California MLPA Master Plan Science Advisory Team
Draft Summary of SAT Water and Sediment Quality Evaluation of Round 3
SCRSG MPA Proposals for the MLPA South Coast Study Region
(Draft revised September 28, 2009)

Overview of MPA Proposal Evaluations Regarding Water and Sediment Quality

Figure 1. Number of coastal MPAs co-located with ASBS, with Northern Channel Islands (NCI) shown separately

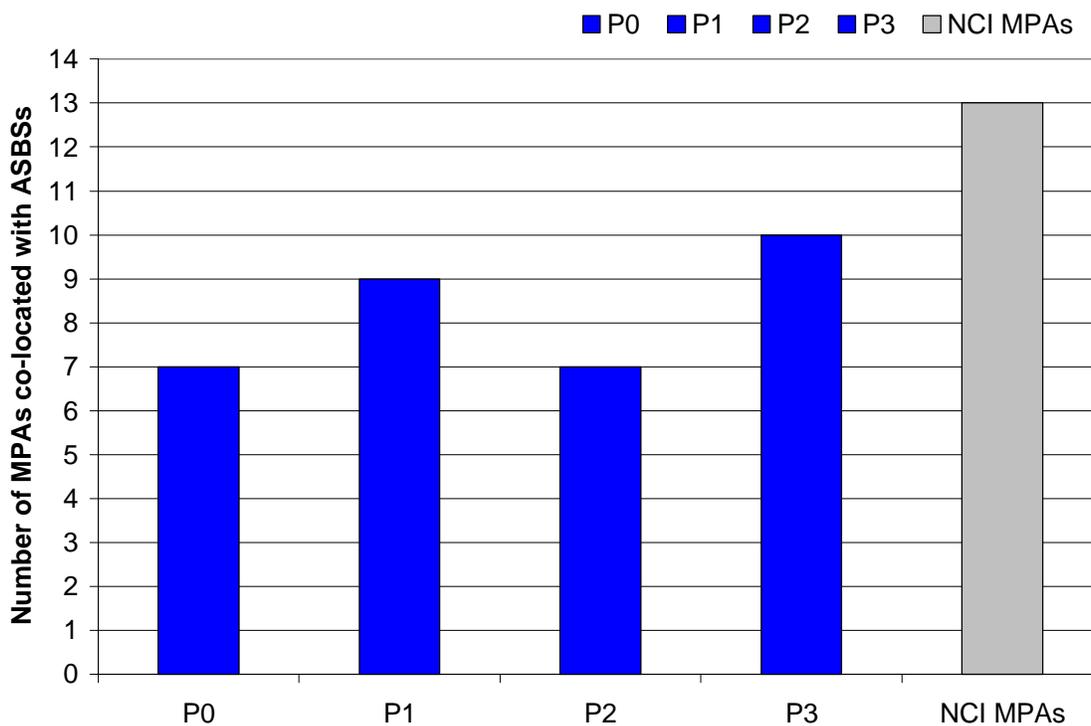
The inclusion of the 13 Northern Channel Islands (NCI) MPAs equally in all proposals helped to improve overall weighted scores due to co-location with large ASBSs at those island MPAs (Figure 1). In addition to being co-located with ASBSs, none of the NCI MPAs are co-located with areas of water quality concern. Therefore all of the NCI MPAs receive the highest score of 1.0 (Table 1). Non-inclusive of the NCI MPAs, the various proposals included between 7 and 10 ASBSs in coastal¹ MPAs.

Figure 2. Scores for all water-quality evaluation categories in a given proposal

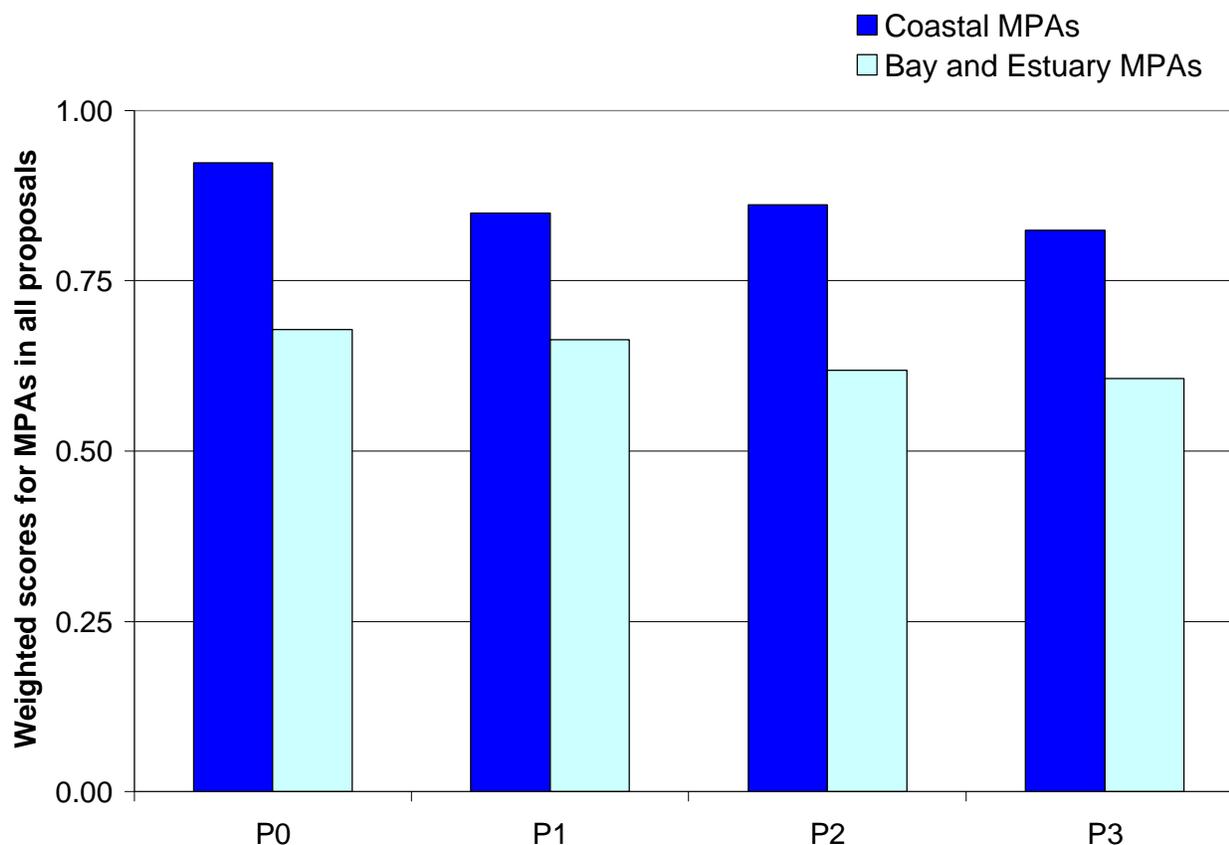
All proposals scored very well for coastal MPAs, with all proposal scores greater than 0.75 (Figure 2). The difference between the highest and lowest scores was very small. Of the three proposals submitted for evaluation, Proposal 2 had the most favorable coastal MPAs scores followed by Proposal 1 and then Proposal 3, although the difference was very small.

Figure 3. Weighted scores and the associated water quality concerns for all Round 2 proposals

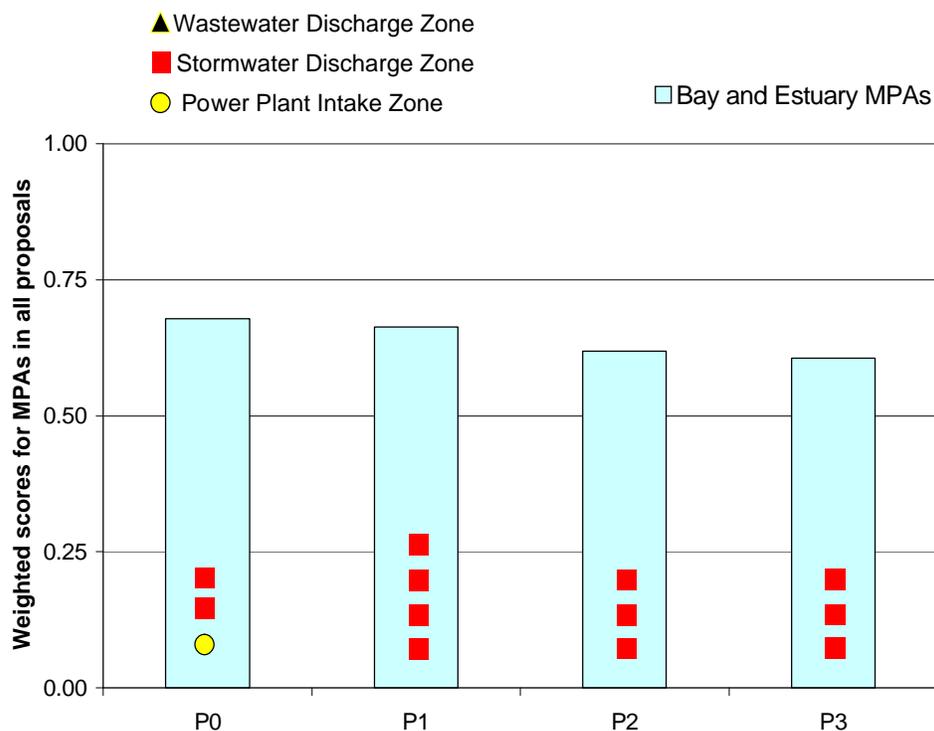
The bay and estuary MPAs scored lower than coastal MPAs for all proposals, with scores ranging from 0.61-0.66 (Figures 2 and 3). This was expected because of the reasons discussed above. All of the proposals included stormwater plumes in certain bay and estuary MPAs. Proposals 2 and 3 included the fewest major stormwater plumes in embayment MPAs, but scored lower overall than Proposal 1 because they included fewer embayment MPAs. It is important to state that all of the proposals did very well in excluding power plant intakes in bay and estuary MPAs. Overall, for bay and estuary MPAs, Proposal 1 had the best water quality score, although the other two proposals also scored well. All three proposals improved on those of the previous round in avoiding water quality concerns within bays and estuaries.

Figure 4. Proposal 0: scores for coastal MPAs with water quality concerns

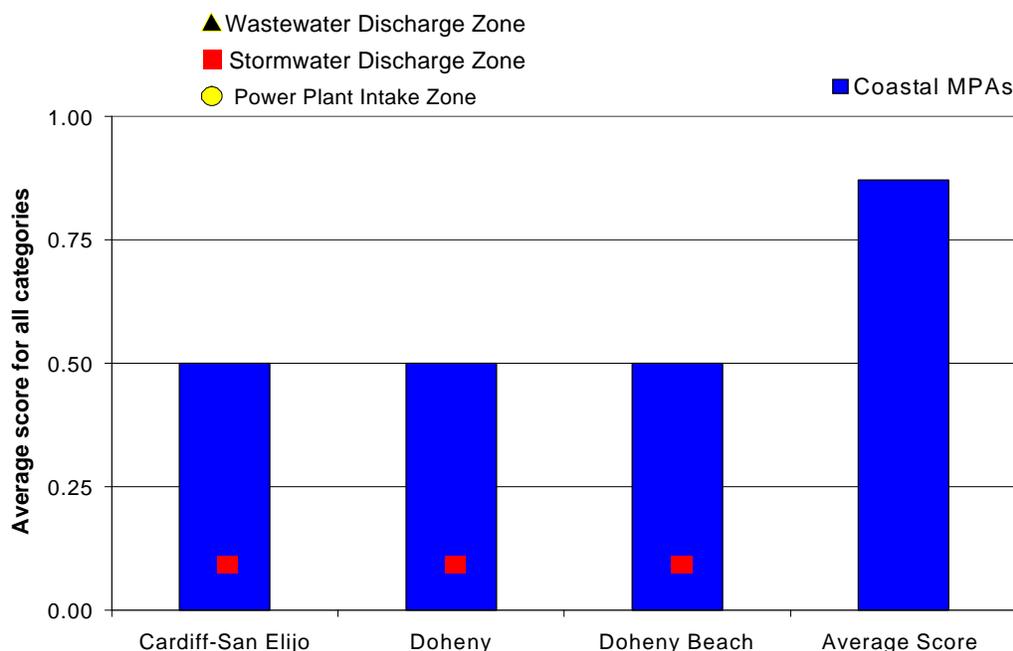
The average score for existing coastal MPAs is 0.87. Excluding the NCI, 19 out of 22 coastal MPAs (86%) scored 0.75 or higher. Also excluding the NCI, seven of 22 (32%) existing MPAs are co-located within ASBSs (Table 2). Only three out of 22 coastal MPAs scored lower than 0.75 (located within stormwater discharge plumes at San Juan and Escondido Creeks) (Figure 4).

Figure 5. Proposal 1: Scores for coastal MPAs with water quality concerns

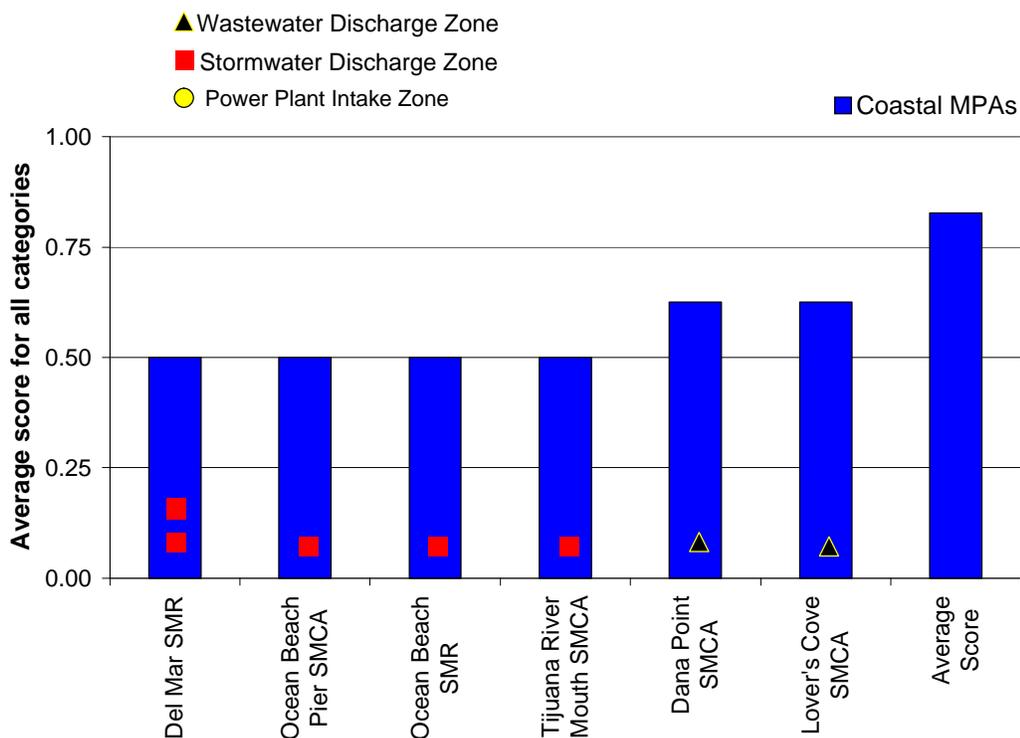
The average score for Proposal 1 coastal MPAs is 0.83 (Figure 5). Excluding the NCI, 23 out of 29 (79%) coastal MPAs scored 0.75 or higher. Excluding the NCI, 9 of 29 (31%) coastal MPAs are co-located within ASBSs (Table 3). There were six coastal MPAs that scored lower than 0.75. Four coastal MPAs (Del Mar SMR, Ocean Beach Pier SMCA, Ocean Beach SMR, and Tijuana River Mouth SMCA) received reduced scores because they were located within major stormwater discharge zones (San Dieguito and Peñasquitos Creeks, San Diego River, and Tijuana River respectively). Del Mar SMR was located within two stormwater discharge zones; the San Dieguito and Peñasquitos Creeks can be found on either side of this MPA. Two

coastal MPAs (Lover's Cove SMCA and Dana Point SMCA) received reduced scores because each intersected an intermediate wastewater outfall's quarter-mile buffer zone (Avalon outfall and Aliso Creek outfall, respectively). It is important to note that these two MPAs did not contain the entire outfall but slightly intersected the outer edge of the outfall's buffer zone.

Figure 6. Proposal 2. Scores for coastal MPAs with water quality concerns and the proposal's average score.

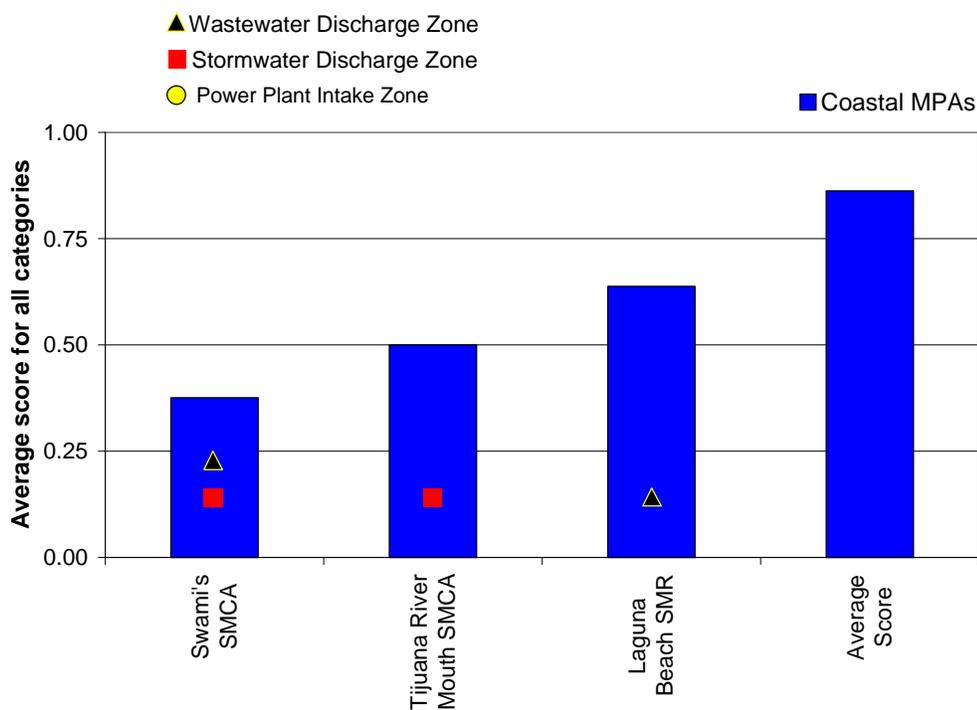
The average score for Proposal 2 coastal MPAs is 0.84 (Figure 6). Excluding the NCI, 17 out of 21 (81%) coastal MPAs scored 0.75 or higher. Excluding the NCI, 7 of 21 (33%) coastal MPAs are co-located within ASBSs (Table 3). There were four coastal MPAs that scored lower

than 0.75. Three coastal MPAs (Del Mar SMR, Ocean Beach SMCA, and Sunset Cliffs SMR) received reduced scores because they were located within major stormwater discharge zones (San Dieguito and Peñasquitos Creeks and San Diego River). One coastal MPA (Lover's Cove SMCA) is co-located with a wastewater discharge zone (Avalon outfall). This MPA slightly touches the outfall's ¼ mile buffer zone.

Figure 7. Proposal 3. Scores for coastal MPAs with water quality concerns

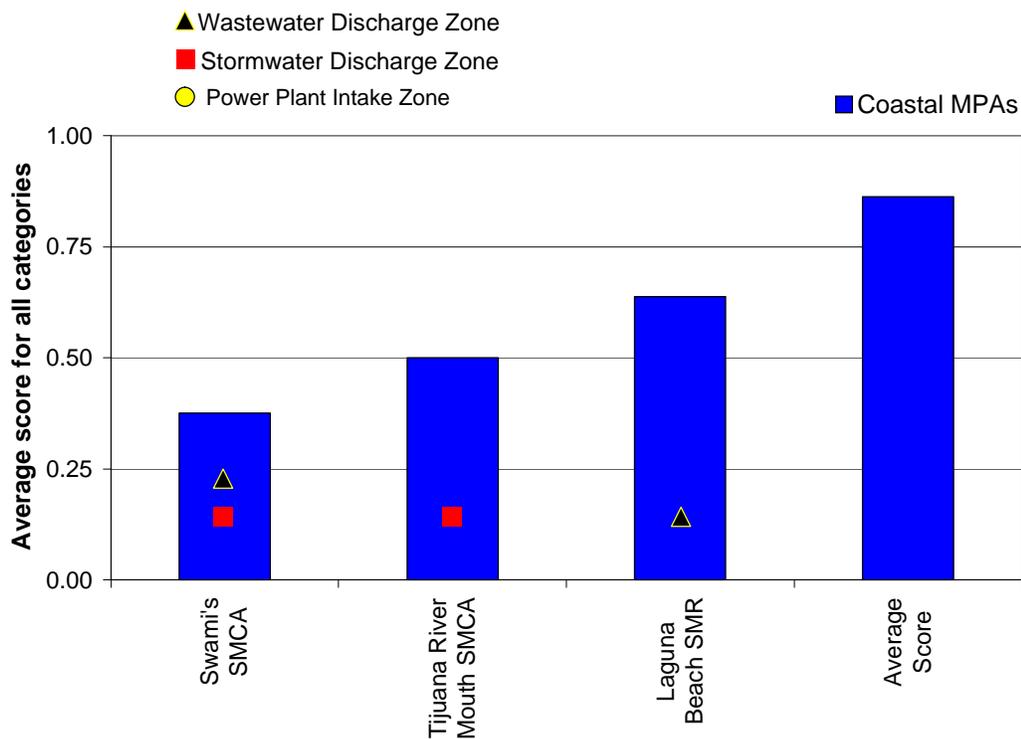
The average score for Proposal 3 coastal MPAs is 0.86 (Figure 7). Excluding the NCI, 20 out of 23 (87%) coastal MPAs scored 0.75 or higher. Excluding the NCI, 10 of 23 (43%) coastal MPAs are co-located within ASBSs (Table 3). There were three coastal MPAs that scored lower than 0.75. Two coastal MPAs (Swami's SMCA and Tijuana River Mouth SMCA) received reduced scores because they were located within major stormwater discharge zones (Escondido Creek and Tijuana River). Swami's SMCA is also co-located with a wastewater discharge zone (San Elijo outfall), while Laguna Beach SMR has a wastewater discharge zone completely contained within it (Aliso Creek outfall).
